S303-24

## TECHNICAL BULLETIN

V6 Engine MIL Lamp On/DTC P0332 –  
Water Entry In Knock Sensor Connector –  
Install Sealing Patch

MODEL 2003-04 MY  
S-TYPE 3.0L  
VIN M44998-N13088

ILLUSTRATION 1

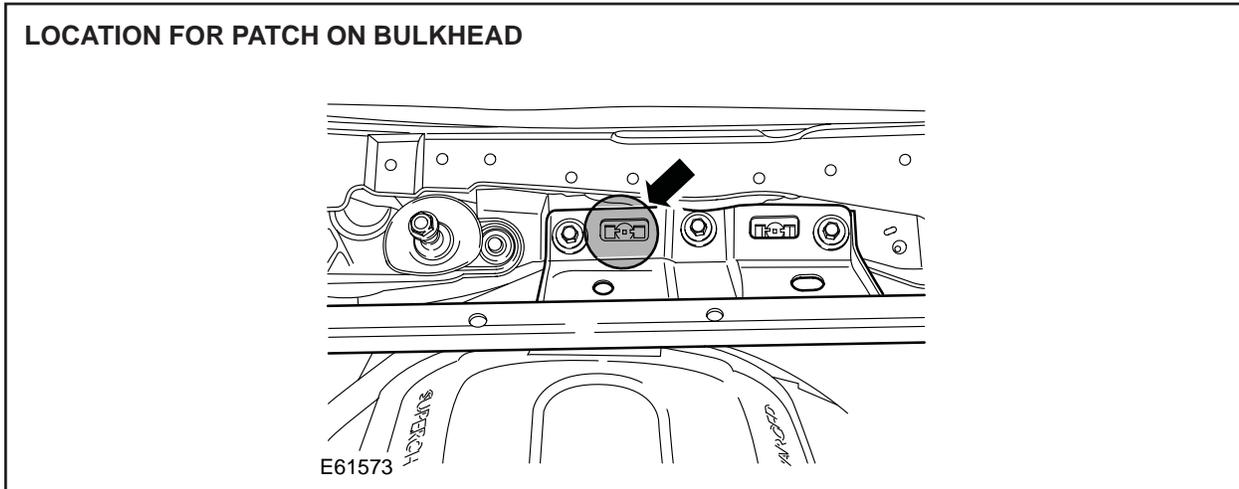
Water can run through the cowl panel fixing hole, on to the engine harness carrier and into the knock sensor.

In case of a customer complaint of the above condition on a 2003-04 MY 3.0L V6 S-TYPE vehicle within the above VIN range, install a new knock sensor, and install a sealing patch on the suspension turret to bulkhead brace. Follow the Service Instruction outlined below.

5. Switch 'OFF' PTU, disconnect from vehicle and return WDS to original location.
6. Remove the cowl panel grille (see Global Technical Reference GTR Workshop Manual, section 501-02).
7. Clean the area on the bulkhead bracket of the suspension turret brace where the adhesive patch will be applied (Illustration 1).

8. Ensure the plastic insert is centered in the rectangular hole of the brace.
9. Remove and discard the backing from the adhesive patch and install the patch centered over right-hand rectangular hole furthest to the rear the brace (see illustration 1).
10. Install the cowl panel grille (see Global Technical Reference GTR Workshop Manual, section 501-02).
11. Remove the **left-hand** (upper) knock sensor (see Global Technical Reference GTR Workshop Manual, section 303-14A, SRO 18.30.92).
12. Remove the engine harness electrical connector for the knock sensor from the mounting, and position it downwards to ensure no water is present in the PVC tube that covers the harness.
